A8-130 – On-board Fire & Primary Hydraulic System Failure

<p>SUBJ: AVIATION SAFETY OCCURRENCE REPORT: 6SQN-075-2007</p>				
<p>REFERENCES:</p> <p>A. AAP 7214.010-6-1M</p>				
<p>1. SERIOUS INCIDENT</p>				
<p>2. MATERIEL/ENGINE/ENGINE FIRE AND HYDRAULIC FAILURE</p>				
<p>3. 01 1530 LOCAL OCT 07</p>				
<p>4. LOCATION: OTHER - PLEASE SPECIFY/YCCA/290/35</p>				
<p>5. ENVIRONMENTAL CONDITIONS: DAY/VMC/N/A</p> <p>WEATHER: SMOKE HAZE</p>				
<p>6. AIRCRAFT DETAILS:</p> <p>F-111/A08C/130/SONIC 1</p> <p>SPEED: 500 TO 600 KIAS</p> <p>ALTITUDE: GREATER THAN 2000 FEET AMSL</p> <p>FLT PATH: CLEAR</p> <p>FLT PHASE: DESCENT</p> <p>LAST DEPARTURE POINT: YAMB</p> <p>INTENDED LANDING POINT: YAMB</p> <p>MISSION: TRAINING/AP13P - OPCON DAY APPLIED PHASE</p>				
DRAFTER'S NAME AND TITLE		OPERATOR		PHONE No
RELEASER'S NAME AND TITLE		BRANCH/UNIT		SIGNATURE
DATE		No OF PAGES		PAGE No
8/10/2007		4		1
				OVERPAGE
				Yes

SUBJ: AVIATION SAFETY OCCURRENCE REPORT: <u>6SQN-075-2007/SASOR-1</u>				
REFERENCES: A. AAP 7214.010-6-1M B. ACG SI (LOG) 2-7-6				
1. <u>SERIOUS INCIDENT</u>

Reference Number: ASOR: 6SQN-075-2007-SASOR 1

A8-130 – LH Engine Bay

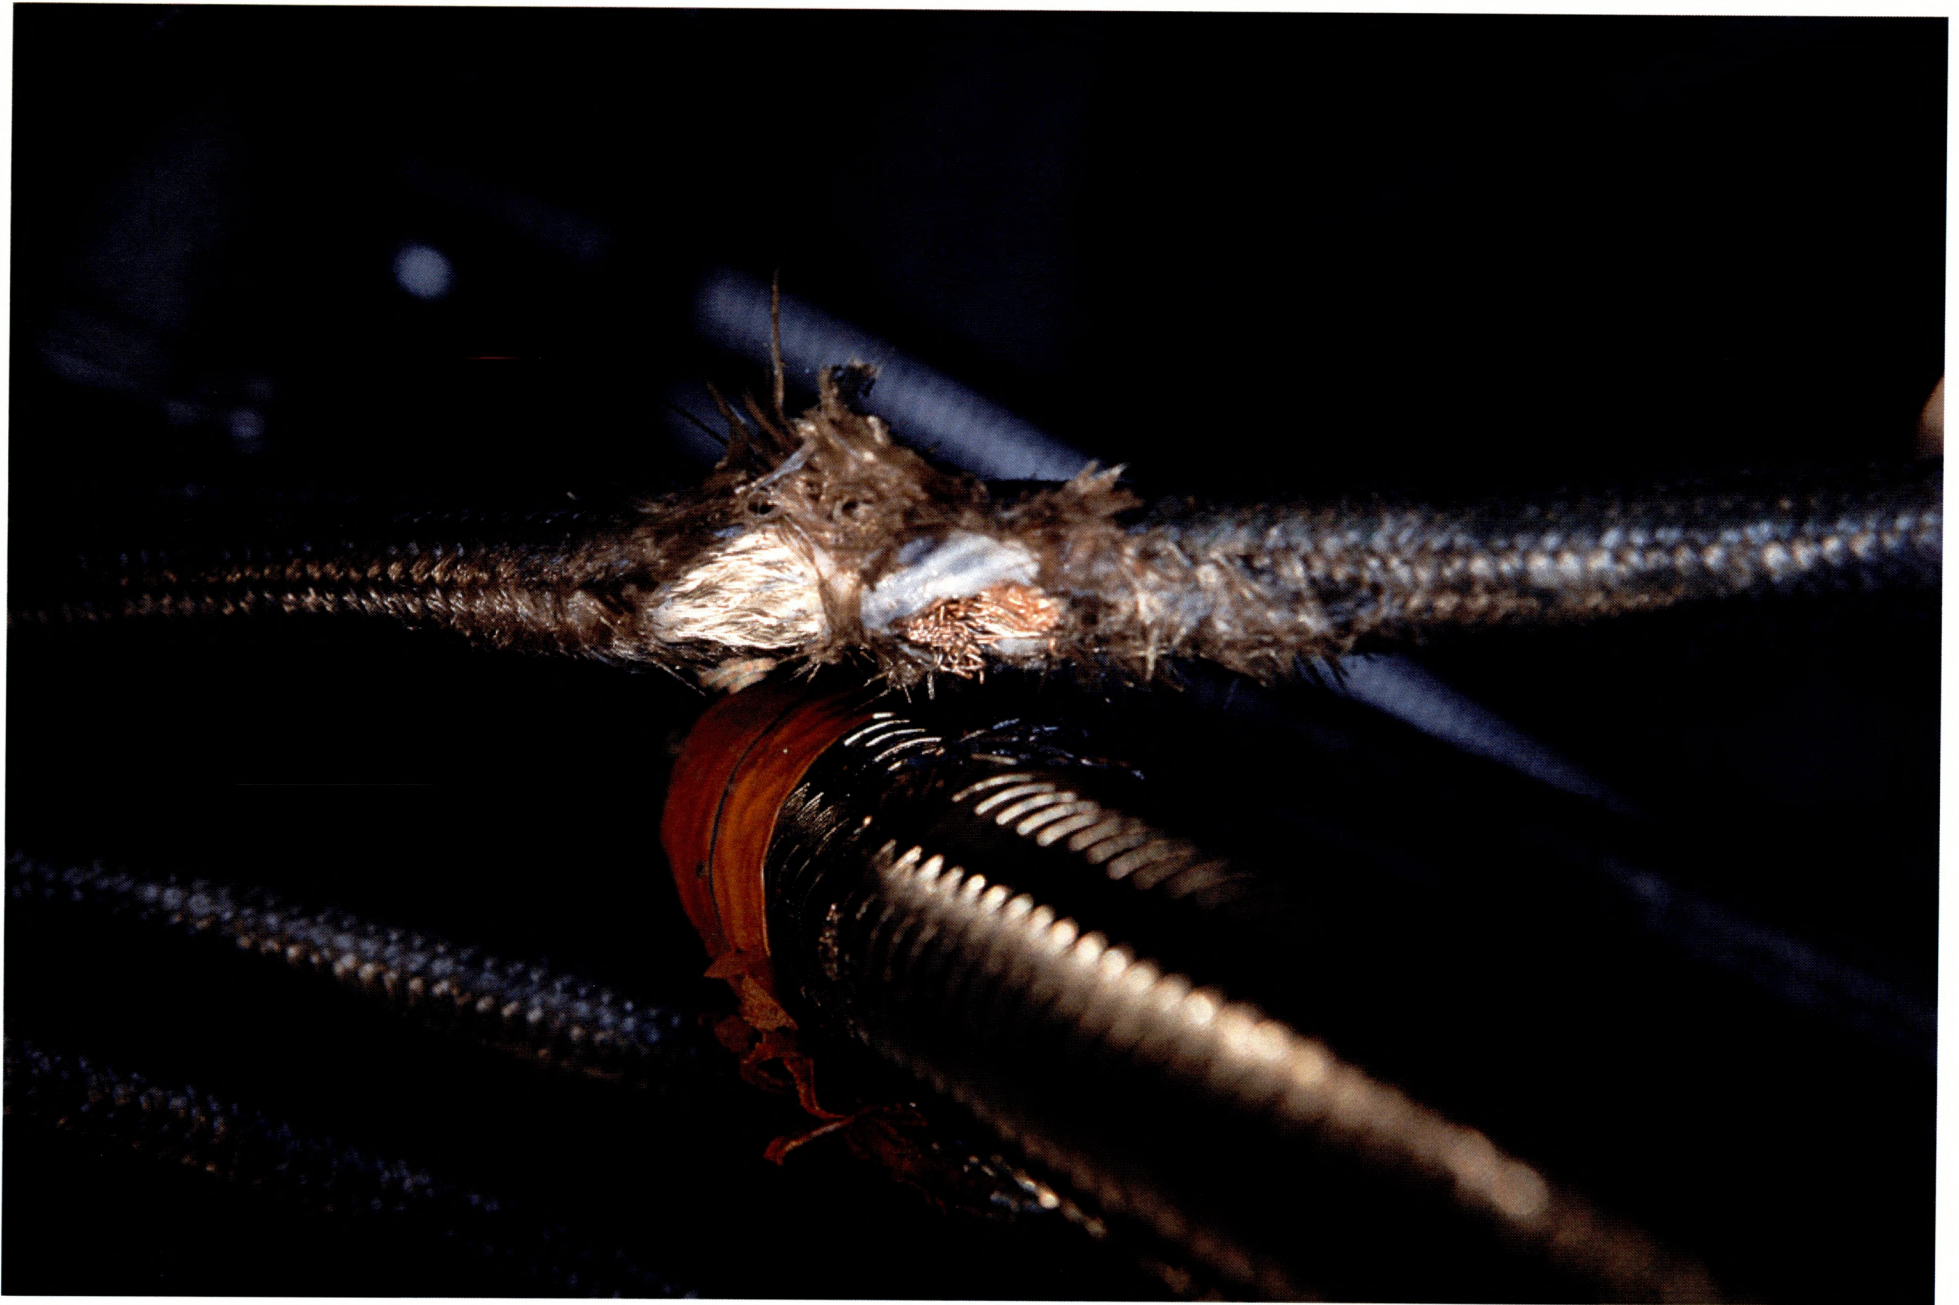
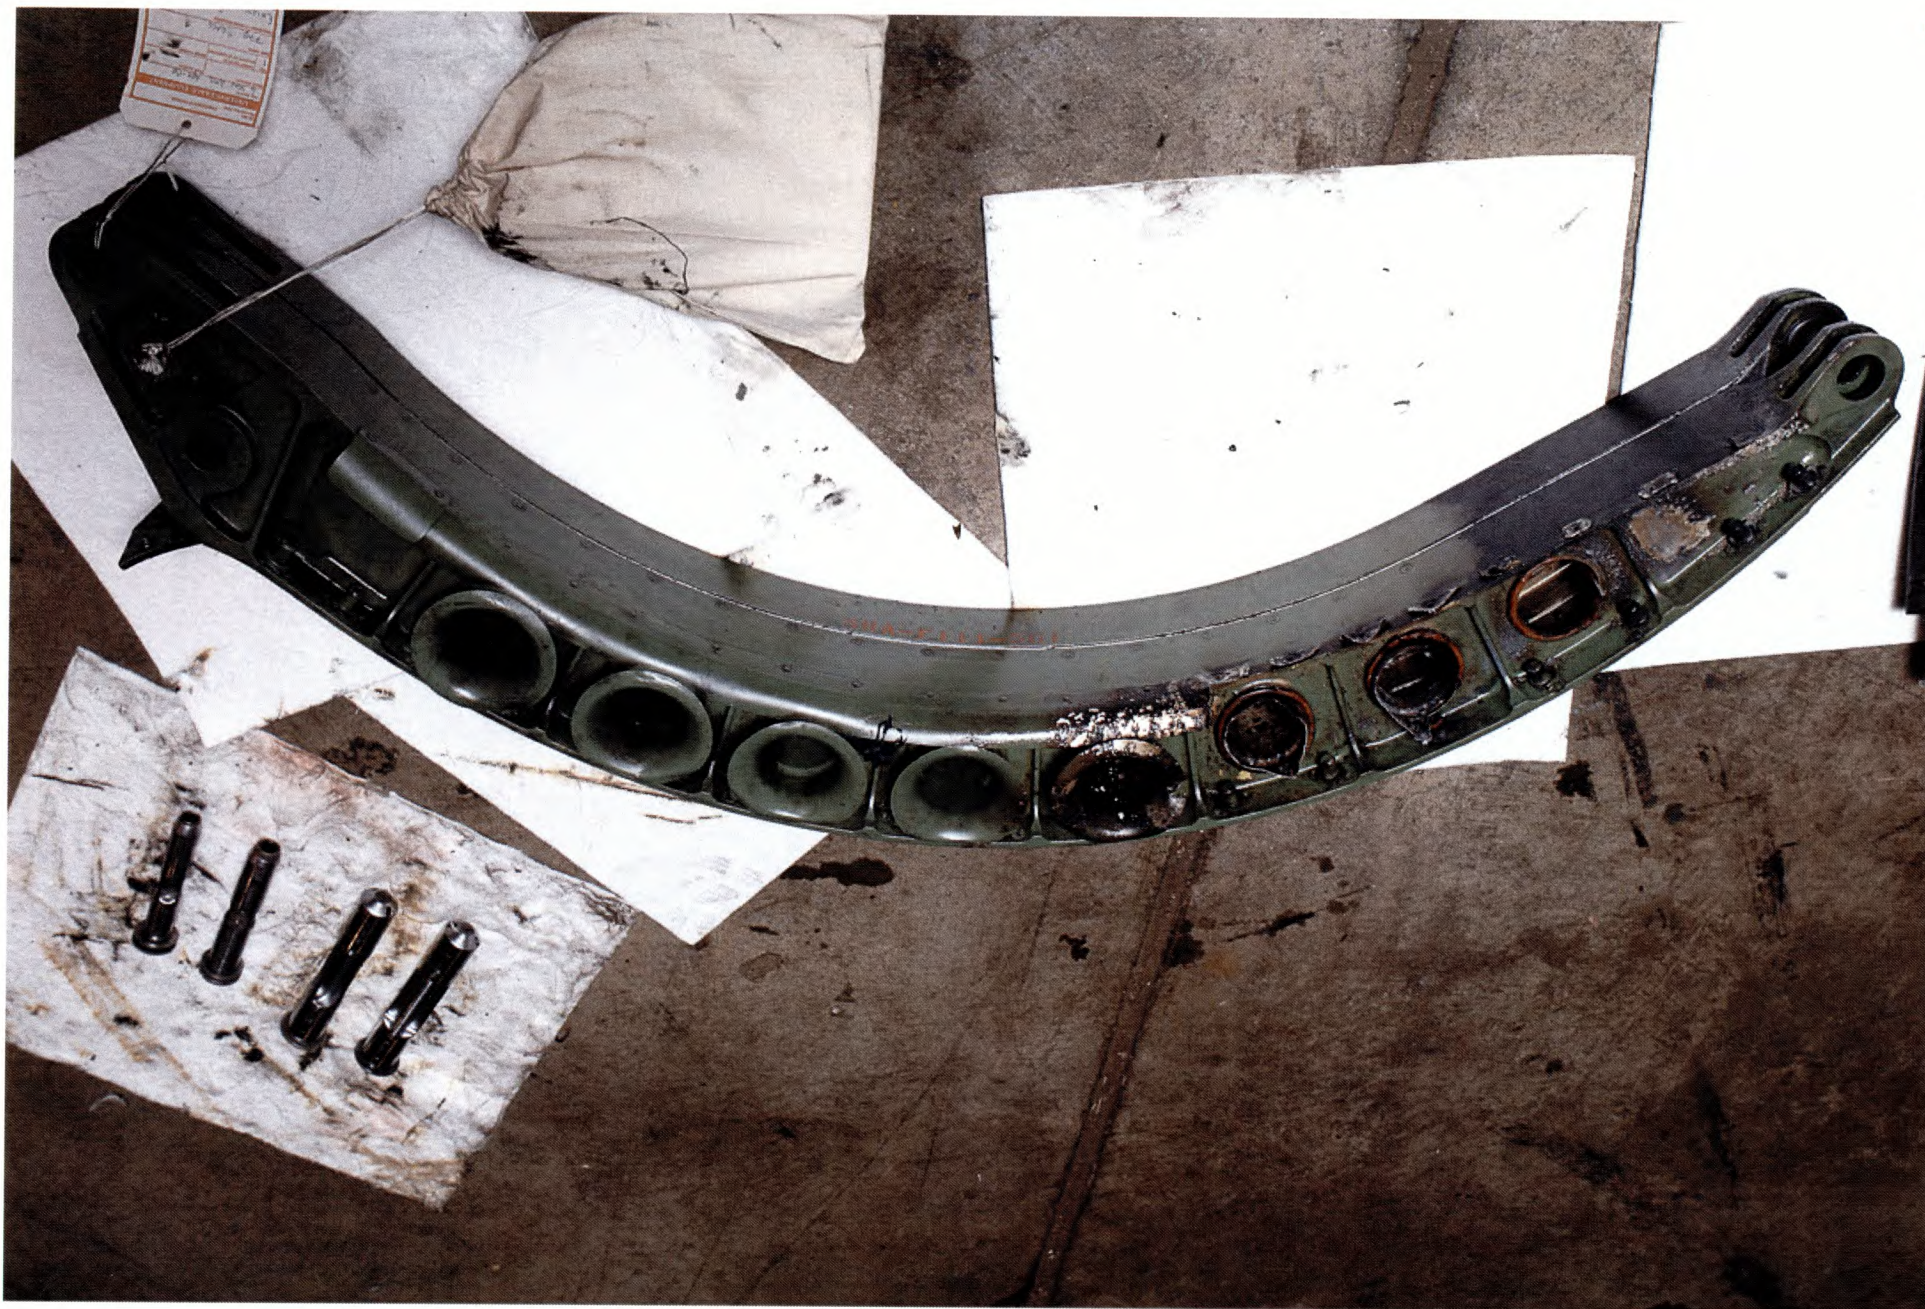
On request from the ASOR I/C, 6SQN maintenance personnel removed the LH engine bay door and inspected for damage. Significant fire damage was evident from the firewall aft along the outboard side of the engine. In particular, fire damage was evident around the hydraulic pumps, engine starter motor and to hydraulic/electrical lines in the area.

A small hole was found on the LH primary hydraulic pump line approximately 30cm aft of the firewall. An AC power line in close vicinity to the small hole showed excessive signs of wear.

A8-130 – LH Engine – Chaffing between Generator DC Cable and Primary Hydraulic Pump Pressure Line

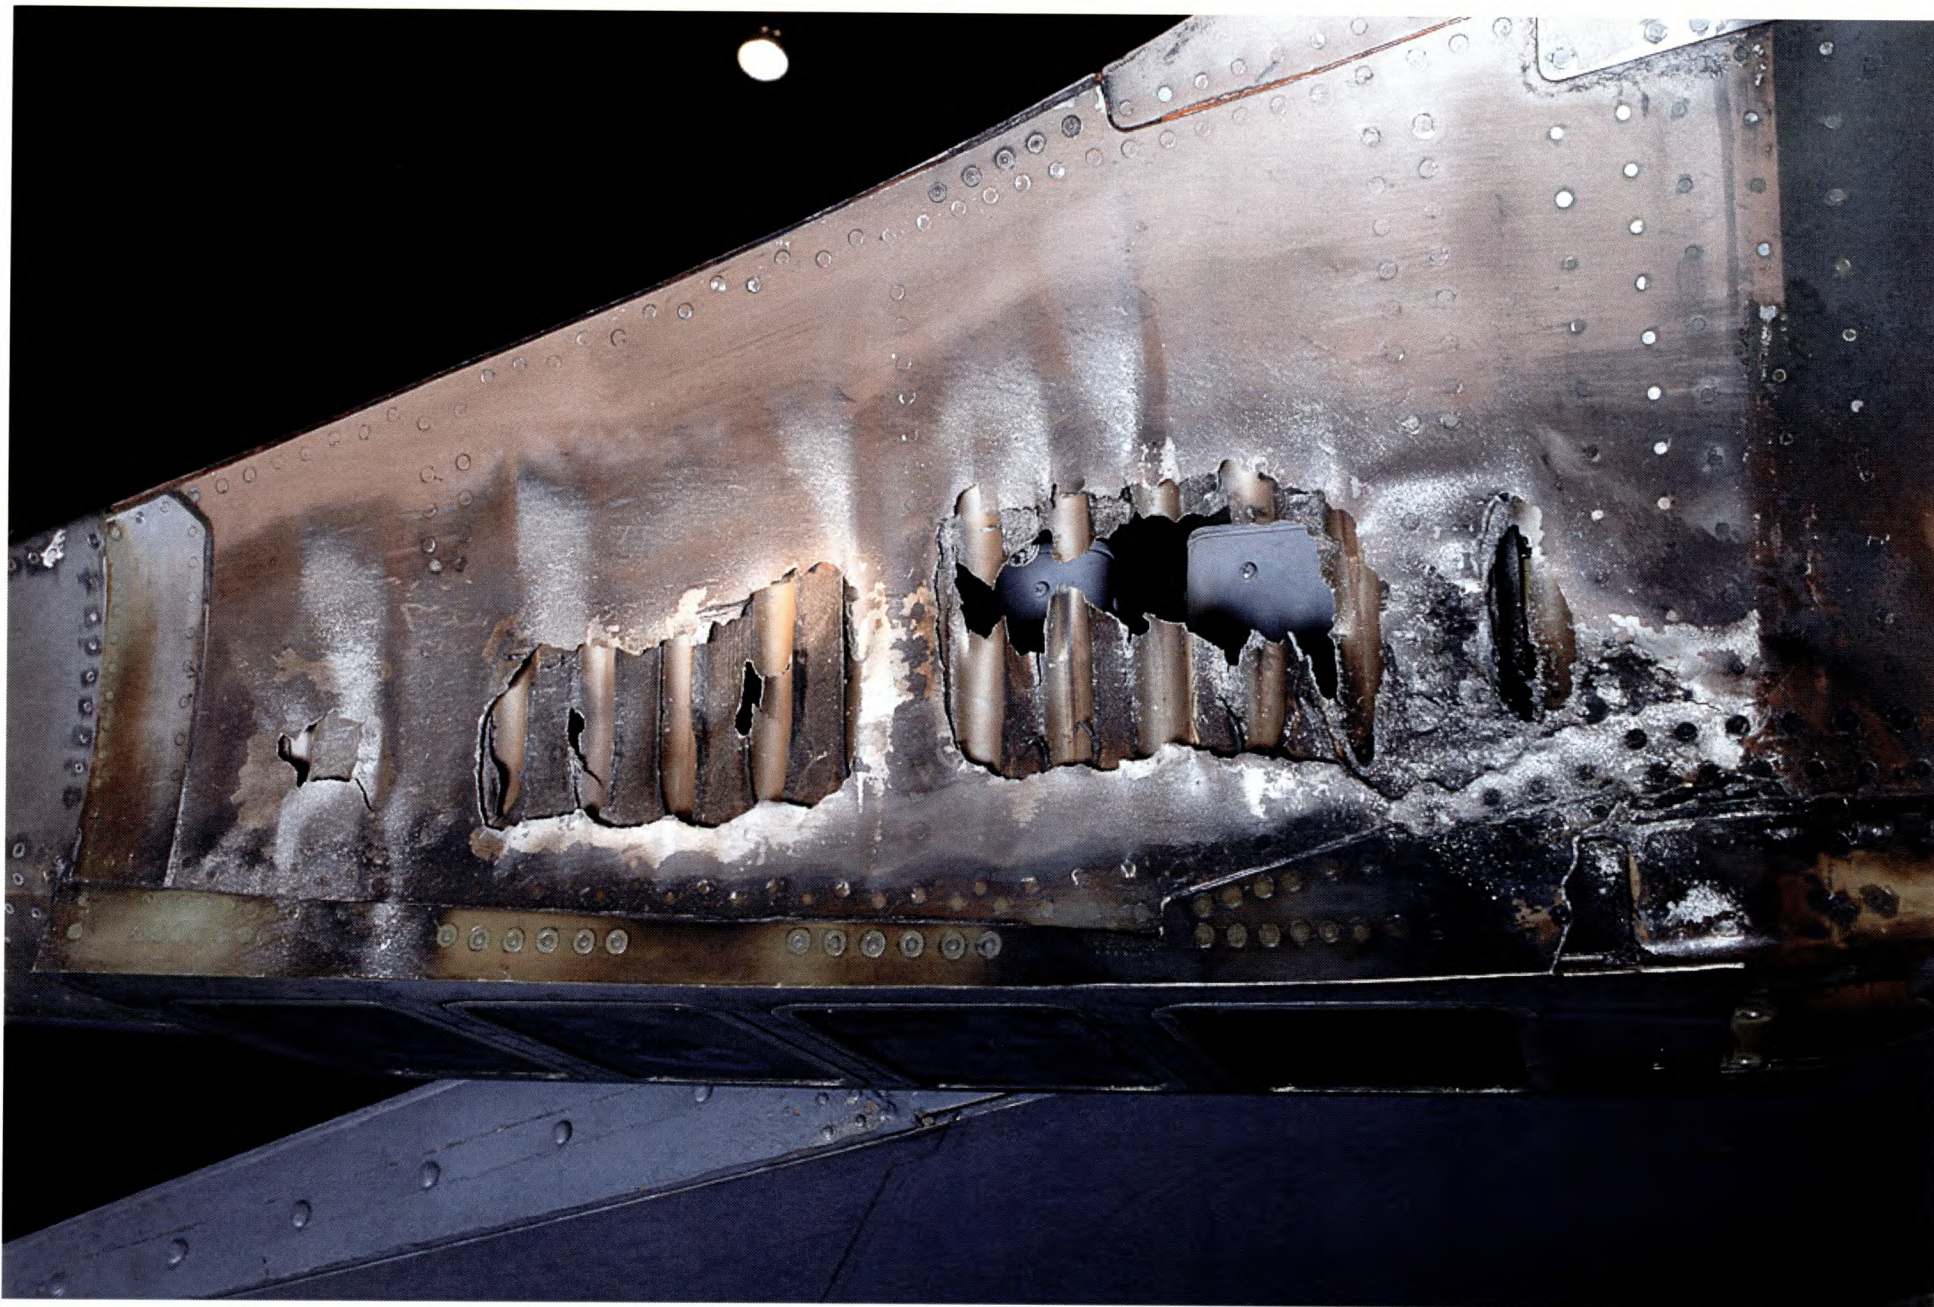
It is likely that the failure is a function of two faults. The first being excessive chaffing to both the hydraulic line and the AC power line. The second being electrical arcing between the two lines.

The probable sequence of events which lead to failure is that the electrical and hydraulic lines experienced sufficient chaffing to enable an electrical connection to occur between the two lines. This electrical connection enabled arcing to occur which burnt a hole at the previously damaged area on the hydraulic line. Hydraulic fluid escaped through the hole, over the AC power line, forward onto the Jacob's Ladder into the cavity between the fuselage and the engine (to the air/oil cooler). The bare wires on the AC power line provide a sufficiently high flashpoint to set alight the hydraulic fluid. The fire followed the fluid path from the Jacob's Ladder to the air/oil cooler, causing significant damage. The excessive loss of hydraulic fluid, coupled with the fire would lead to a LH engine fire indication and a primary hydraulic failure (LH and RH) indication in the cockpit. In addition, the bleed duct sensor line is located in close vicinity to the damaged lines. As such, a fire in this area would cause a LH bleed air duct failure indication in the cockpit.

a - Electrical cables are now being fitted with heat shrink IAW Boeing Service Bulletin STK07-SB-00487 to provide cables with an additional layer of protection.

All hydraulic lines (including installed and uninstalled serviceable assets) have been fitted with scuff guard IAW the applicable OEM drawing.
